Access Compliance Report

Public Rights-of-Way

Intersection ID: 11408	Main Street: N_SMITH_ST	Cross Street: W_8TH_ST	Location: S
ADA ID: EF6FE16B9F40	Ramp Type: PerpDiag	Initial Pass/Fail: Fail	Overall Compliance: No
		Severity Score: 10

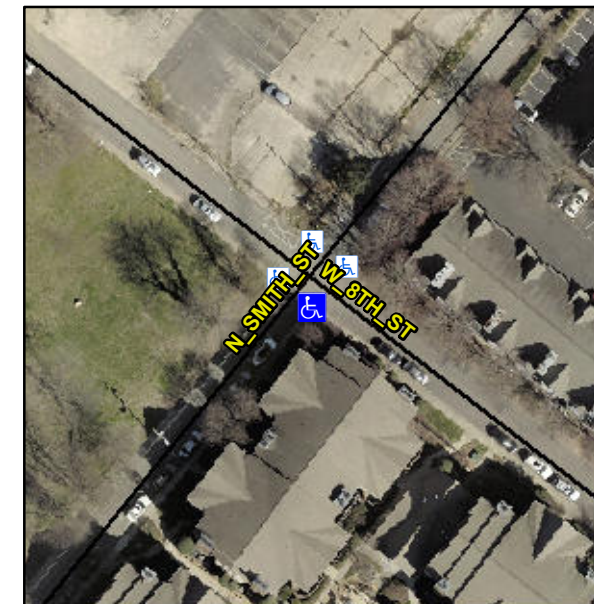
Not Found, R304.5.1, R304.5.3

Compliance	Description	Data	Compliance	Description	Data
N/A	Ramp Length (in)	66.0	Yes	Ramp Slope (%)	6.0
No	Ramp Width (in)	39.0	No	Ramp XSlope (%)	3.9
N/A	Flare Type LT	N/A	N/A	Flare Type RT	N/A
N/A	Flare Slope LT (%)	N/A	N/A	Flare Slope RT (%)	N/A
N/A	Flare Traversable LT?	N/A	N/A	Flare Traversable RT?	N/A
N/A	Landing Length (in)	N/A	N/A	DWS Provided?	N/A
N/A	Landing Width (in)	N/A	N/A	DWS Contrast?	N/A
N/A	Landing Slope (%)	N/A	N/A	DWS Length (in)	N/A
N/A	Landing X Slope (%)	N/A	N/A	DWS Full Width?	N/A
N/A	Landing Curb? (Y/N)	N/A	N/A	DWS Offset (in)	N/A
N/A	Shared Landing?	N/A			
N/A	Gutter Ponding?	N/A	N/A	Gutter Slope (%)	N/A
N/A	Gutter Lip Ht (in)	N/A	N/A	Gutter X Slope (%)	N/A
N/A	Painted X Walk1?	No	N/A	Painted X Walk2?	No
	X Walk 1 Direction	To NE		X Walk 2 Direction	To NW
N/A	X Walk 1 Width (in)	N/A	N/A	X Walk 2 Width (in)	N/A
	X Walk 1 Slope (%)	5.4		X Walk 2 Slope (%)	1.8
	X Walk 1 X Slope (%)	2.9		X Walk 2 X Slope (%)	6.4

Remove & Replace Curb Ramp With Two New Directional Ramps or Equivalent.
